Bid 638
New HVAC Modernization Project for Oxnard High School

BID CLARIFICATION ADDENDUM #1

Dated: November 01, 2020

Bid Clarification Addendum #1
Attachment A
Signet Controls RFI

BUILDING G ELEVATION 1/8" = 1'-0" 1

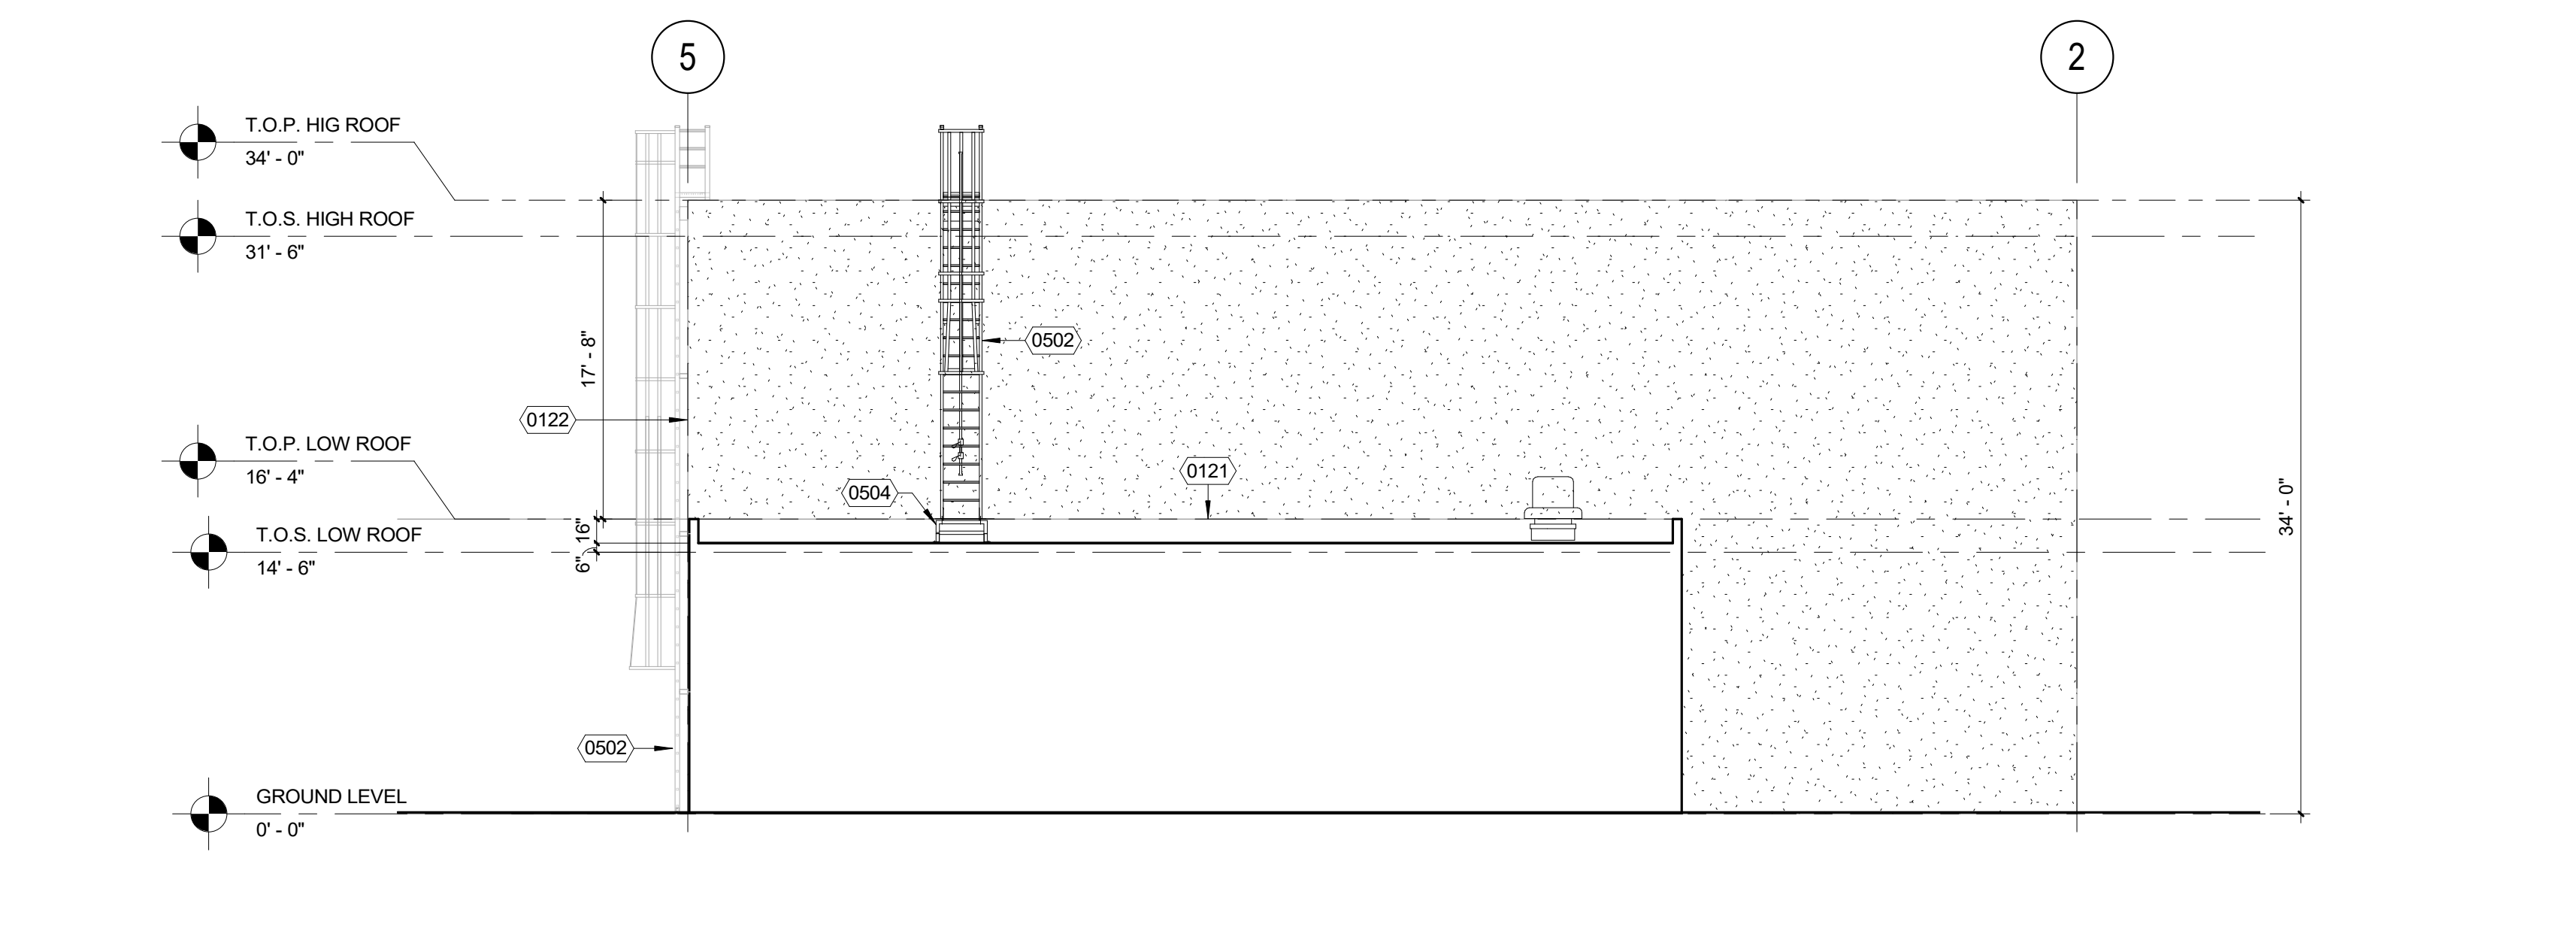
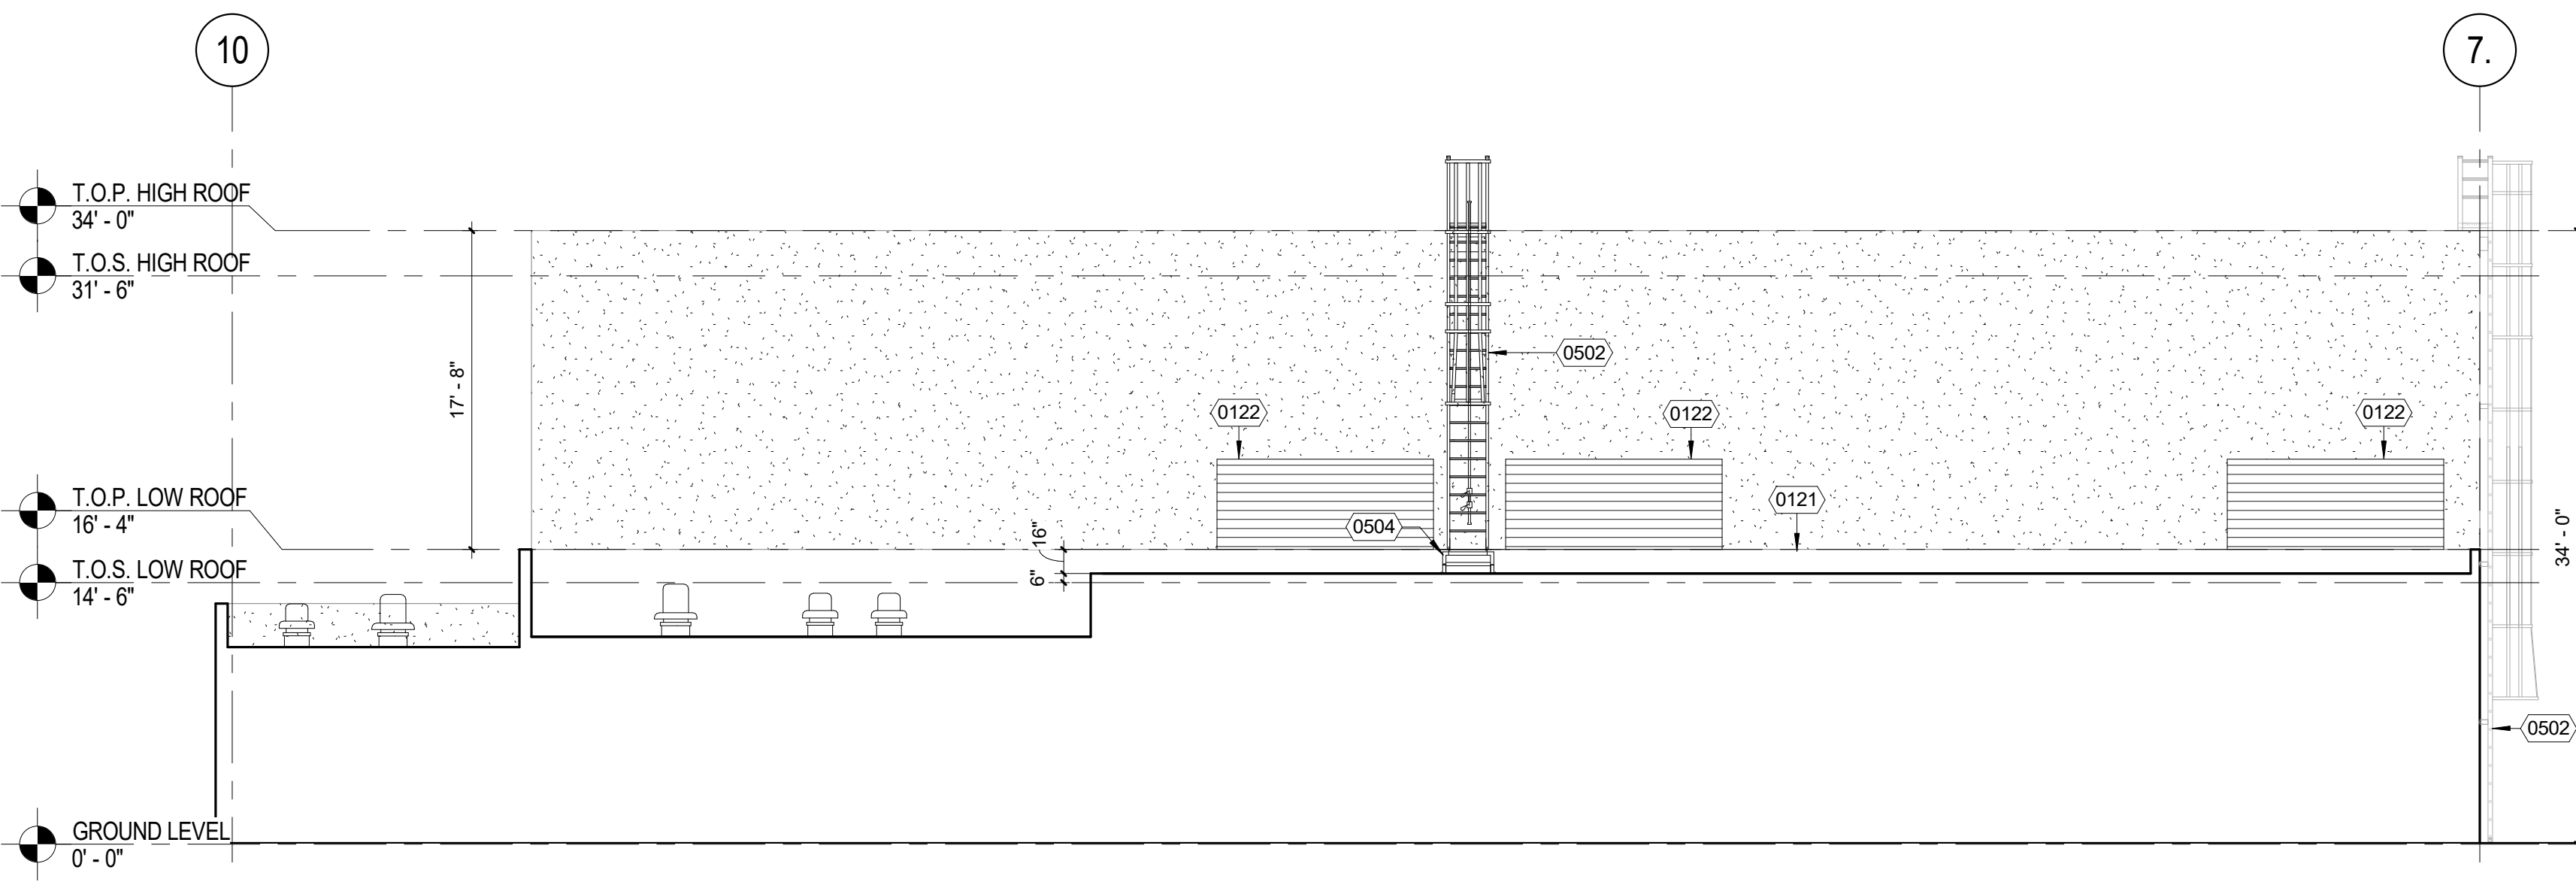
- A. Add the attached new Drawing 10.1 in its entirety.
